The Commission has issued the enclosed Amendment No. 98 to Facility Operating License No. DPR-59 for the James A. FitzPatrick Nuclear Power Plant. The amendment consists of changes to the Technical Specifications in response to your request dated October 11, 1985.

The amendment revises the Technical Specifications to (1) permit reactor operation with one recirculation loop out of service and (2) include General Electric Company's Service Information Letter (SIL) No. 380, Revision 1 recommendations regarding thermal-hydraulic stability for dual loop and single loop operation.

AMENDMENT TO FACILITY OPERATING LICENSE

Amendment No. 98
License No. DPR-59

Figure 3.5-1
Thermal Power and Core Flow Limits of
Specifications 3.5.J.1, 3.5.J.2 and 3.5.J.3

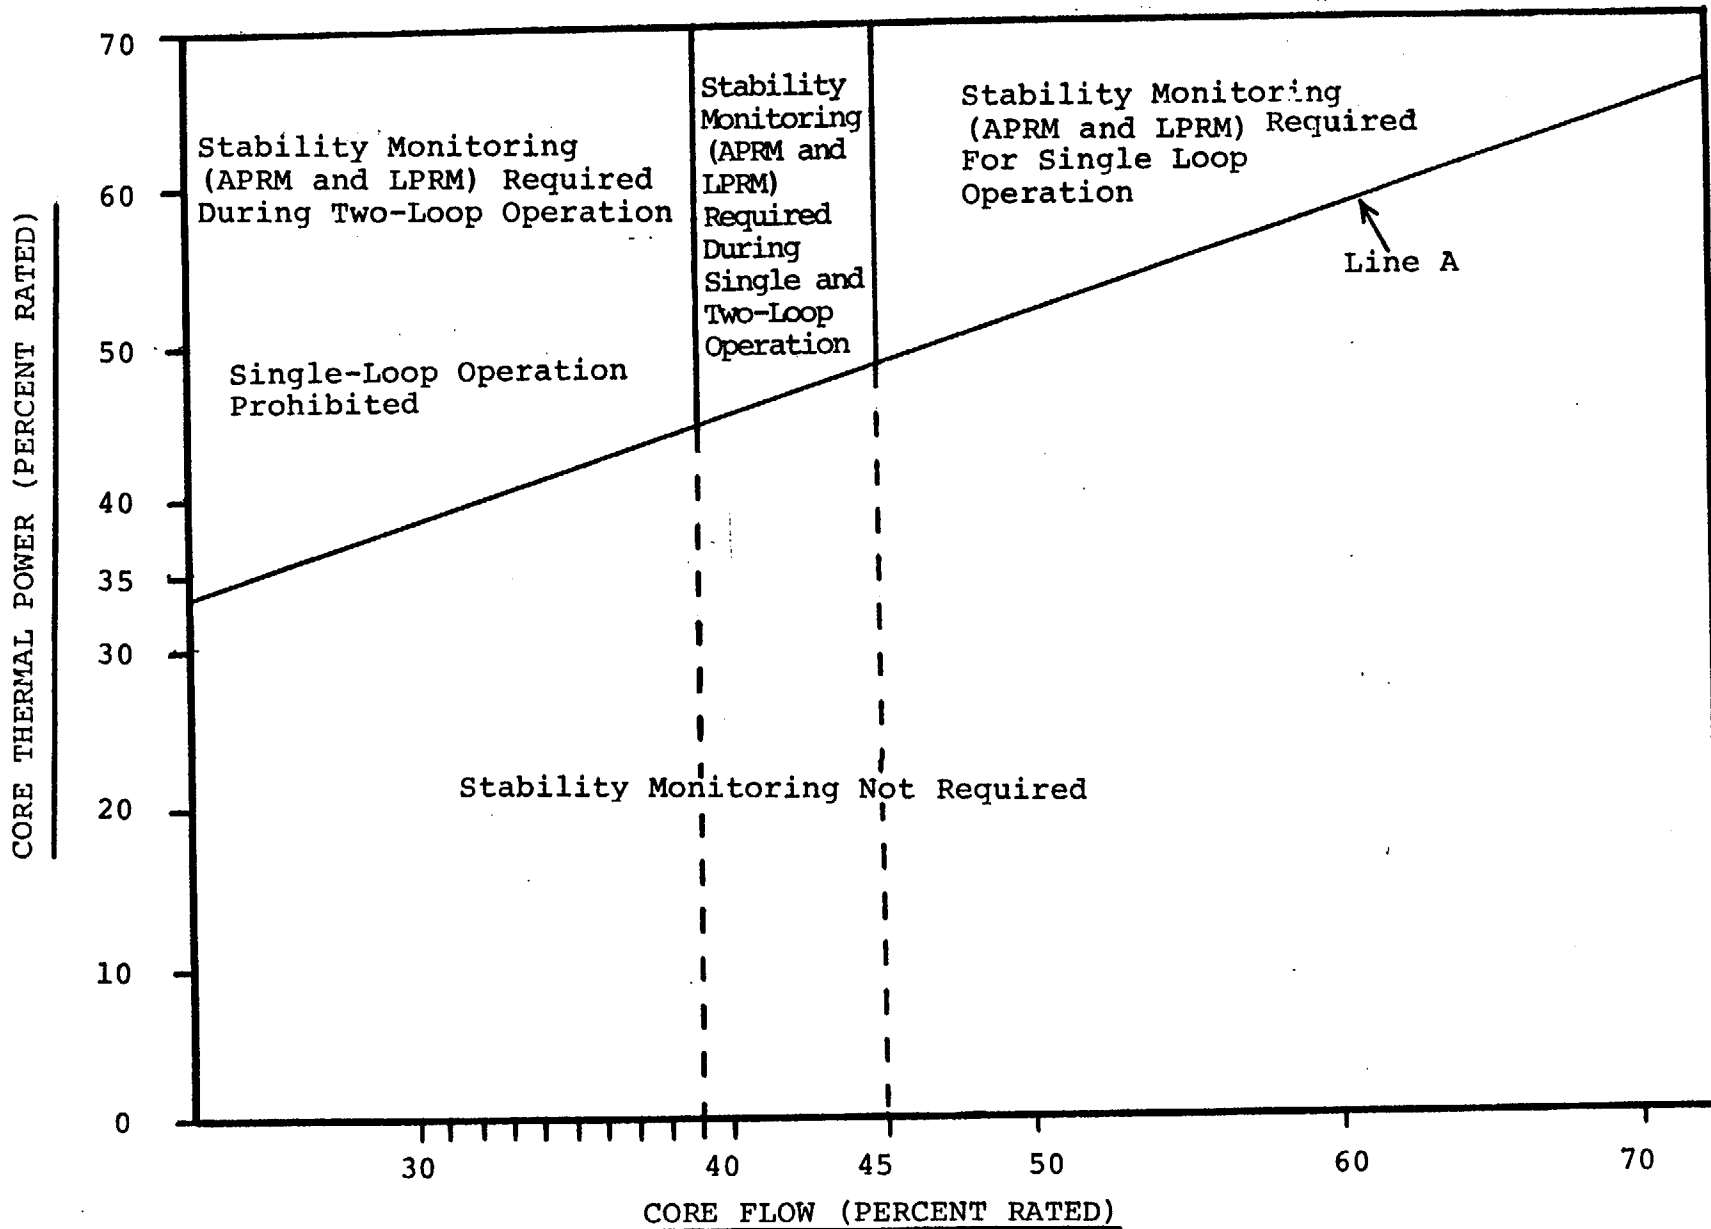
1. Whenever the reactor is in the startup or run modes, two Reactor Coolant System recirculation loops shall be in operation, with:
 - a. Total core flow greater than or equal to 45 percent of rated, or
 - b. Thermal power less than or equal to the limit specified in Figure 3.5-1 (Line A).

2. With two Reactor Coolant System recirculation loops in operation and total core flow less than 45 percent of rated, and thermal power greater than the limit specified in Figure 3.5-1 (Line A); or with one Reactor Coolant System loop operating and thermal power greater than the limit specified in Figure 3.5-1 (Line A):
 - a. Determine the APRM and LPRM noise levels:
 1. Within 2 hours after reaching steady-state within the regions of Figure 3.5-1 where monitoring is required, and at least once per 8 hours thereafter; and

3. If during single-loop operation, core thermal power is greater than the limit defined by line A of Figure 3.5-1, and core flow is less than 39 percent, immediately initiate corrective action to restore core thermal power and/or core flow to within the limits, specified in Figure 3.5-1, by increasing core flow and/or initiating an orderly reduction of core thermal power by inserting control rods.

5. Specifications 3/4.5.J, including Figure 3.5-1, have been added to provide operating limits and surveillance requirements for thermal-hydraulic stability. These TS implement the recommendations of SIL 380 and are similar to other approved TS (References 7 and 8). These TS set up appropriate power-flow regions, time frames, and action levels for establishing baseline and active monitoring of LPRM and APRM levels for both one and two loop operation.

Figure 3.5-9

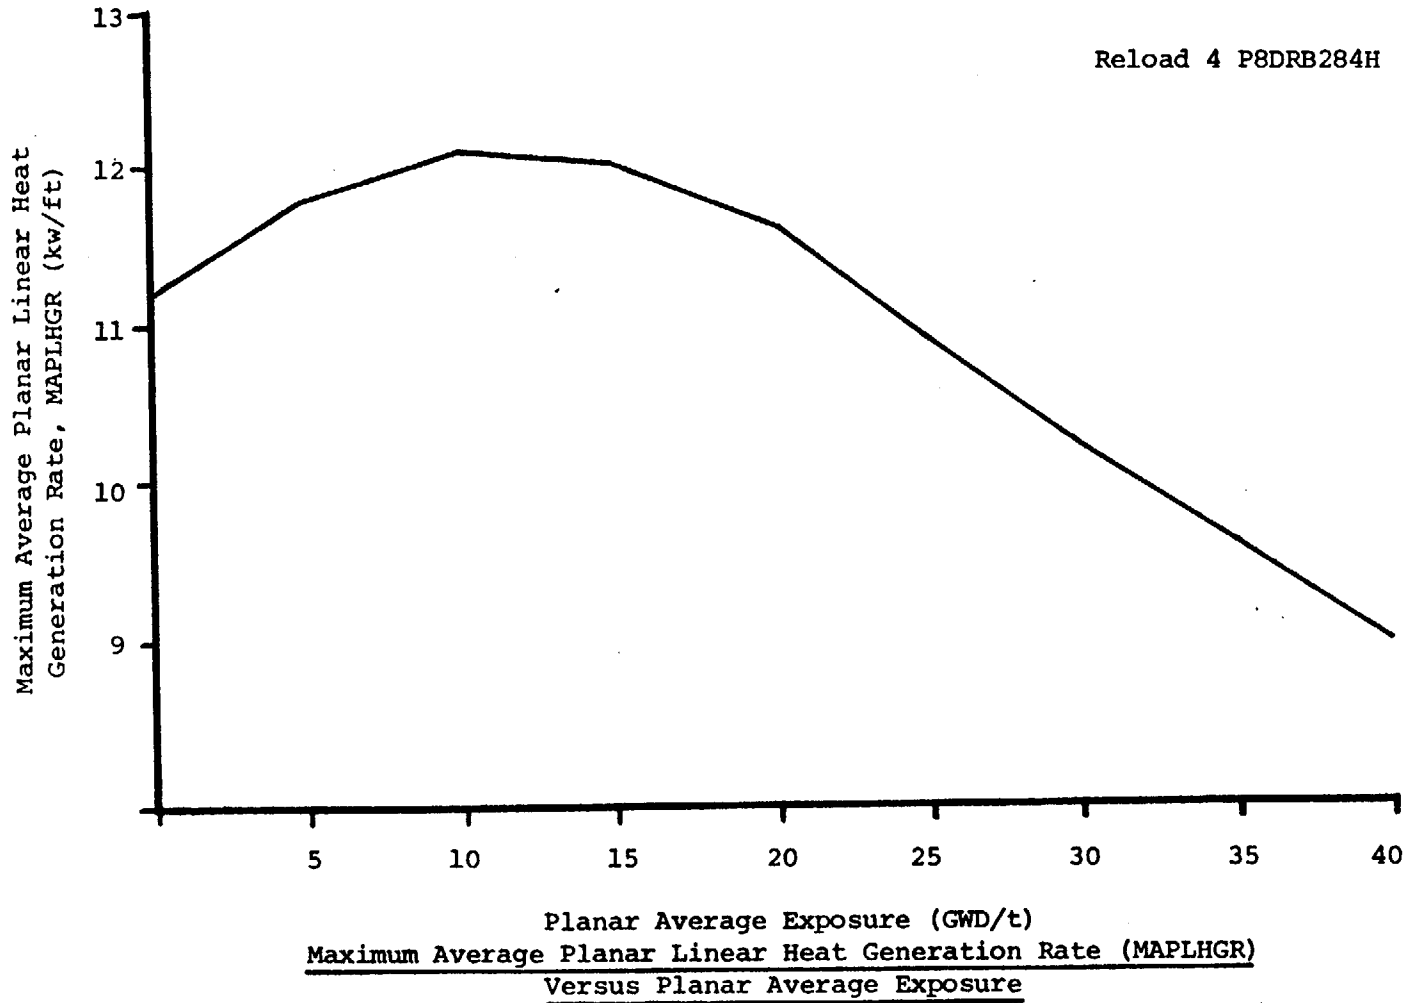
The APLHGR for each type of fuel as a function of average planar exposure shall not exceed the limiting value shown in Figures 3.5-9 through 3.5-11 for two loop operation. For single loop operation these values are reduced by multiplying by 0.84 (see Specification 3.5.K, Reference 1). If anytime during reactor power operation greater than 25% of rated power it is determined that the limiting value for APLHGR is being exceeded, action shall then be initiated within 15 minutes to restore operation to within the prescribed limits. If the APLHGR is not returned to within the prescribed limits within two (2) hours, an orderly reactor power reduction shall be commenced immediately. The reactor power shall be reduced to less than 25% of rated power within the next four hours, or until the APLHGR is returned to within the prescribed limits.

For single-loop operation, these MAPLHGR values are multiplied by 0.84.

Figure 3.5-10

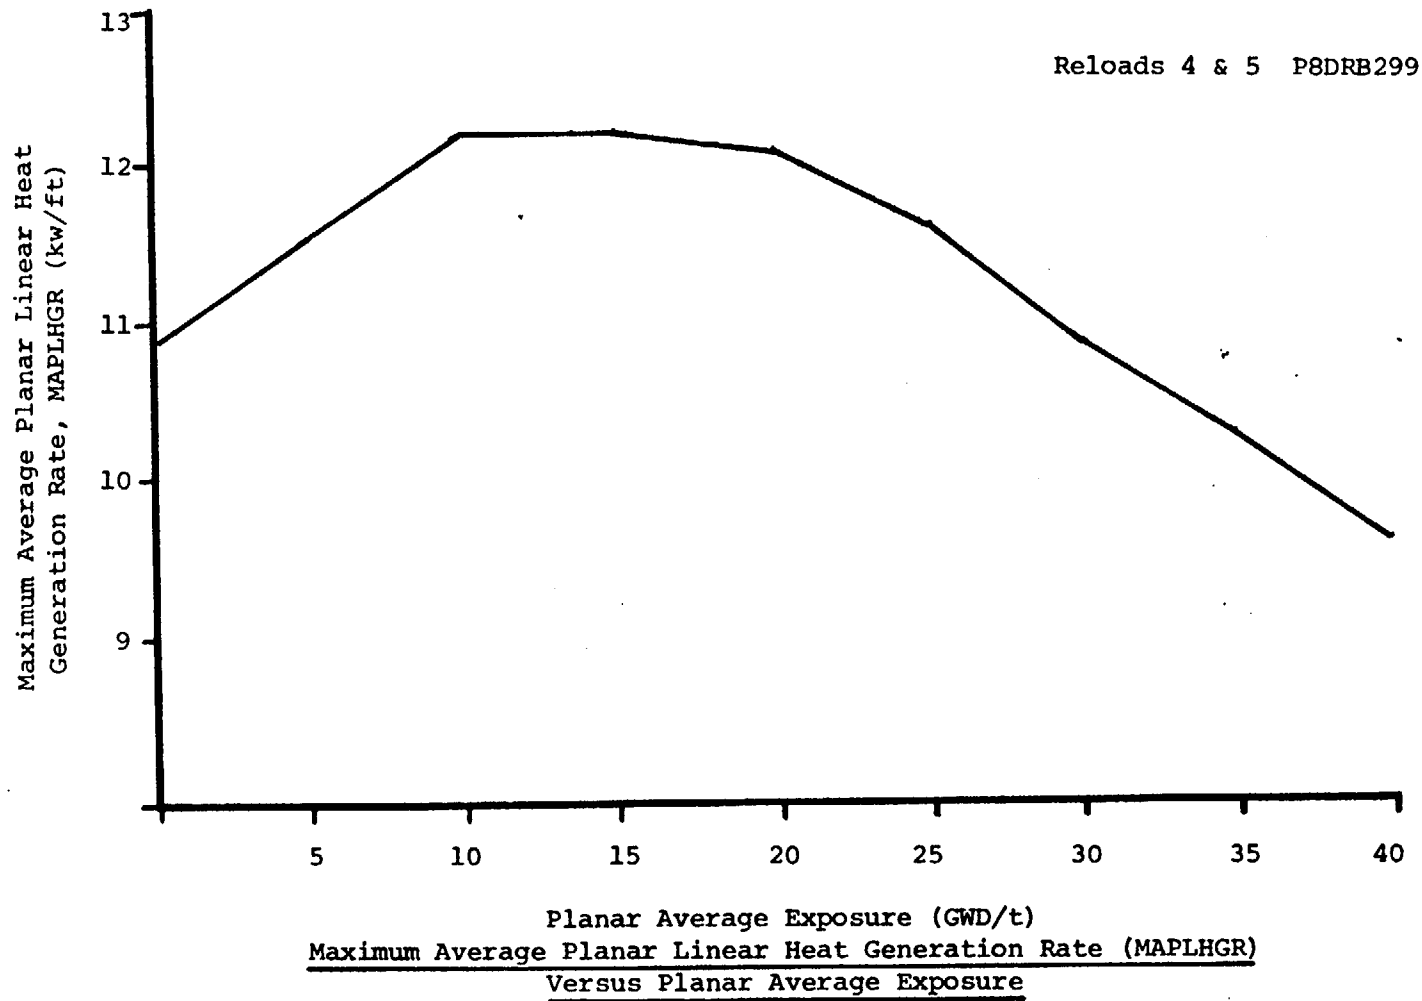
For single-loop operation, these MAPLHGR values are multiplied by 0.84.

Figure 3.5-11

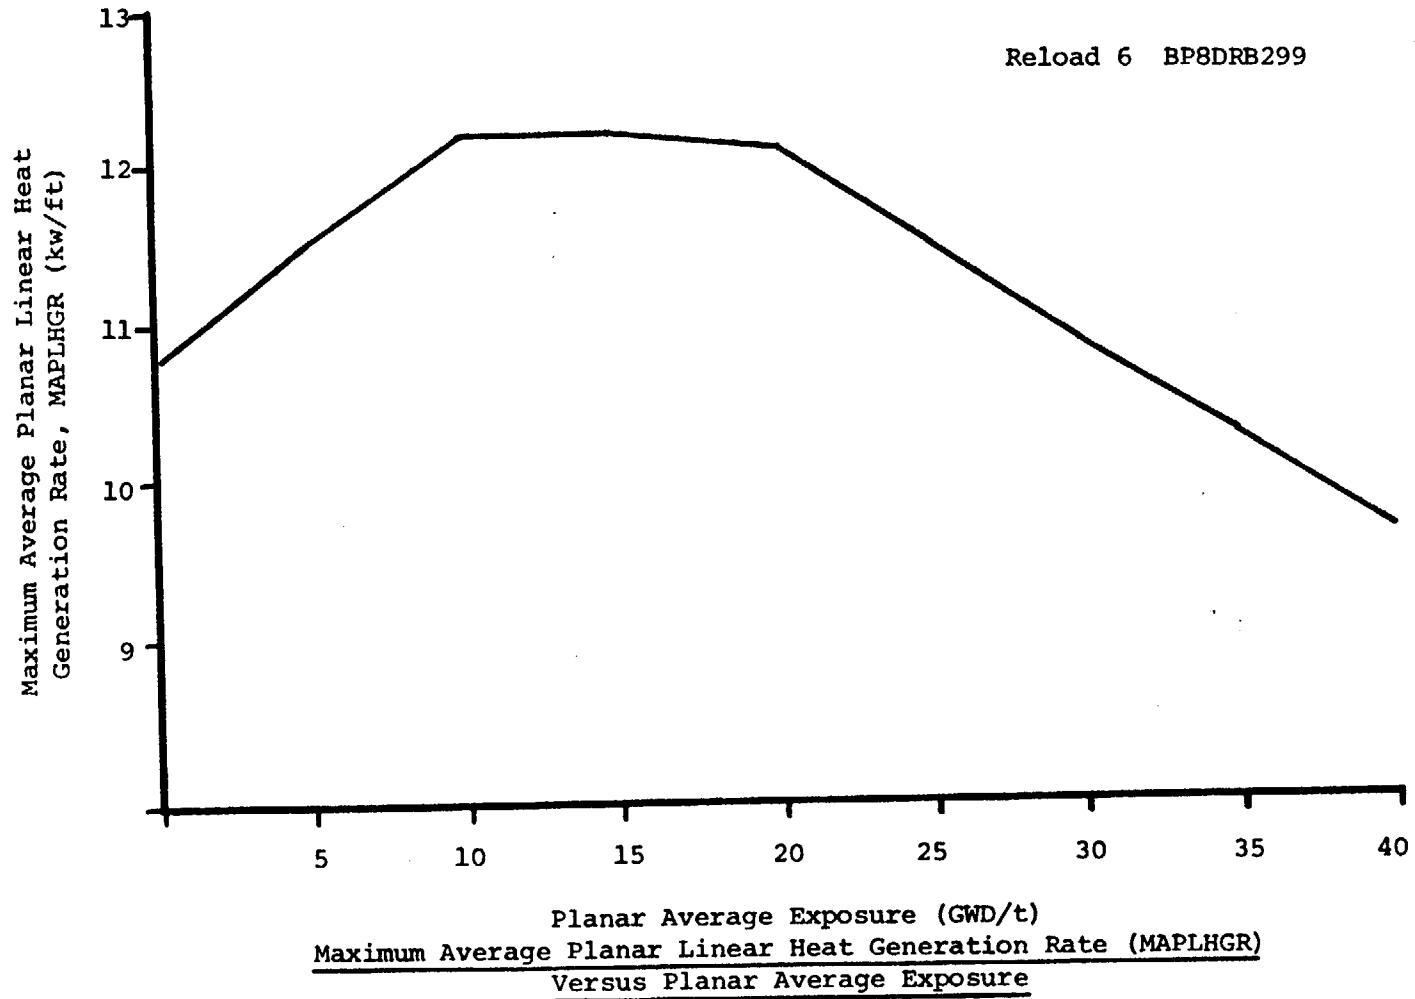
For single-loop operation, these MAPLHGR values are multiplied by 0.84.
